ADDENDUM #2 – APRIL 12, 2023

RE: **COQUILLE HIGH SCHOOL**
CTE Shop Renovation
Project #21.03

FROM: HGE ARCHITECTS, Inc.
333 South 4th Street
Coos Bay, Oregon 97420
541-269-1166

SK-01

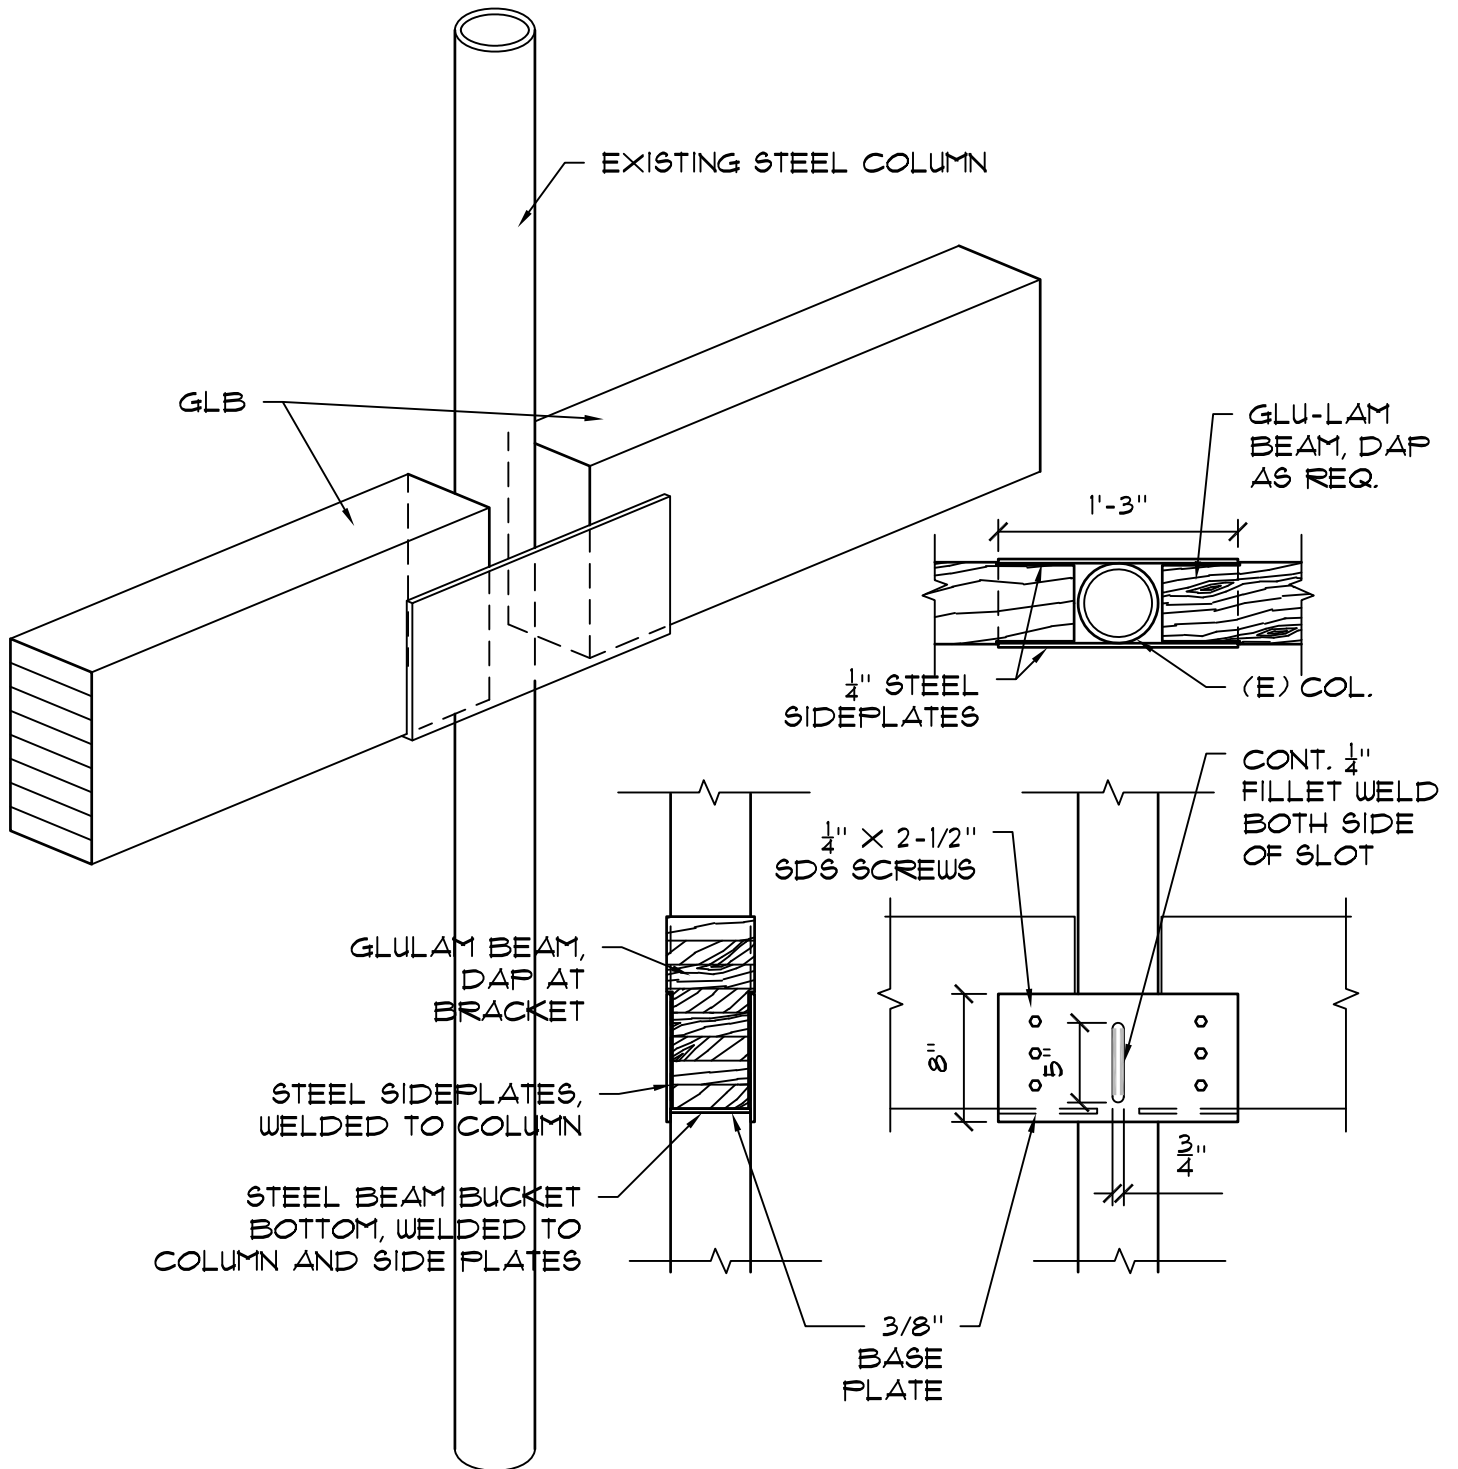
- e. See attached sketch SK-01, regarding beam/column connection for 5 ½” x 12” glulam beam in CTE Lobby 110.
- f. AGR/MACH. CLASSROOM 103: CHANGE stainless steel counter and sink to “Owner Furnished, Contractor Installed”.
